TECHNICAL SERVICE BULLETIN: 1.5in. Capstan Cable Guard, Rev B

Original Bulletin: November 17, 2022

CORRECT CONTROL CABLE POSITION OUTSIDE KEEPER BRACKET FINGERS

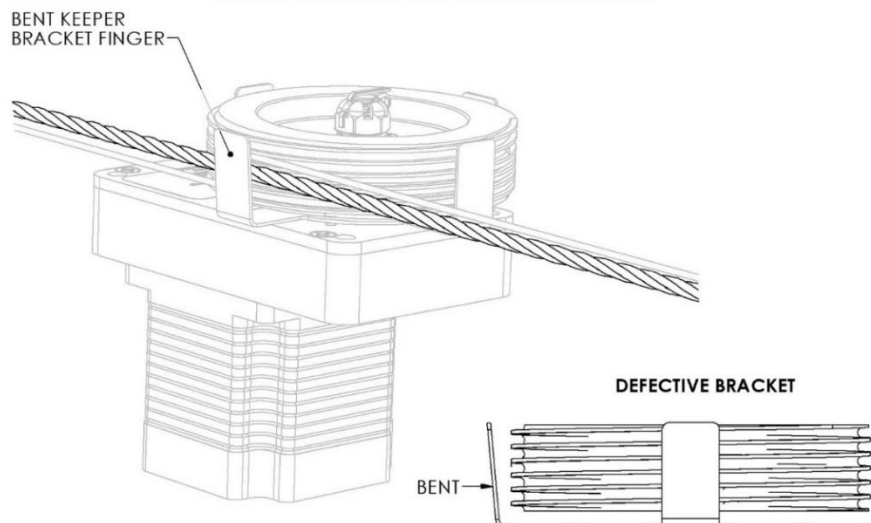
The fingers of the cable guard for the pitch servo's 1.5in. capstan used on Bonanza 35 and 36 models can be bent, potentially creating an out-of-specification gap between the capstan and the guard. This gap may allow the elevator control cable to jump over the capstan guard, positioning itself between the capstan and the cable guard (see figure below).

INCORRECT CONTROL CABLE POSITION INSIDE KEEPER BRACKET FINGERS

1. Prior to next flight, and every 25 hours thereafter, perform a visual inspection of the pitch servo installation to verify the elevator cable is not positioned between the capstan and cable guard. This action may be performed by the owner/operator (pilot) holding at least a private pilot certificate.

- c. If the elevator control cable has positioned itself between the capstan and the cable guard, notify Dynon Technical Support.
2. Within 12 months after the effective date of this service bulletin or 100 flight hours, whichever comes first, replace the pitch servo's capstan guard with a new Dynon-provided product (P/N 103535-001). To request the part, fill out and submit the following form: [Service Bulletin Cable Guard Request Form](#).

BRIDLE CABLE REMOVED FOR CLARITY

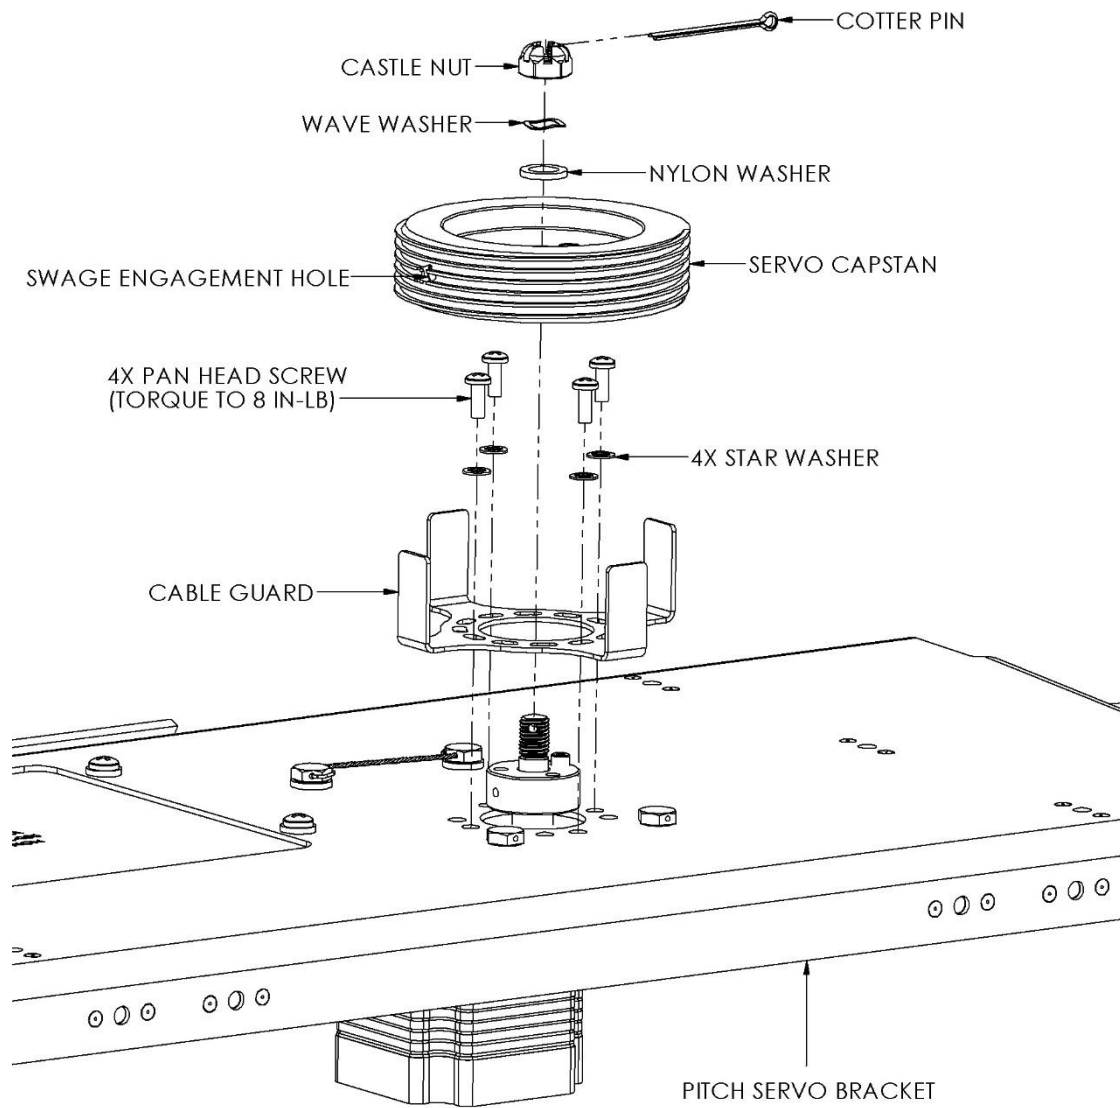
Reference the figure below when performing the following procedure.

- m. Remove screws and star washers that secure capstan guard to servo.
- n. Remove old and replace with new capstan guard.
- o. Secure capstan guard to servo with screws and star washers.

- r. Finger-tighten castle nut onto servo shaft, and then use a wrench to tighten until slot in castle nut lines up with hole for cotter pin in servo shaft.
DO NOT overtighten the castle nut! Tightening castle nut beyond 4 in-lbs may prevent the capstan from rotating freely in event of shear screw failure.

- u. Ensure bridle cable does not contact cable guard. Adjust cable guard position as necessary.
- v. Tension and temporarily secure bridle cable to 15–20 lbs. Make sure swage engagement hole is in same position as noted in step 'f'.
NOTE: The tension on the bridle cable should never exceed the tension on control cable.

- w. When satisfied with tension and capstan position, tighten all bridle cable clamp nuts to 35-40 in-lb.
- x. Use a feeler gauge to measure gaps between bridle cable clamp halves (top and bottom). Make sure gap measurements on both sides of clamp are not less than 0.003" and not more than 0.050".
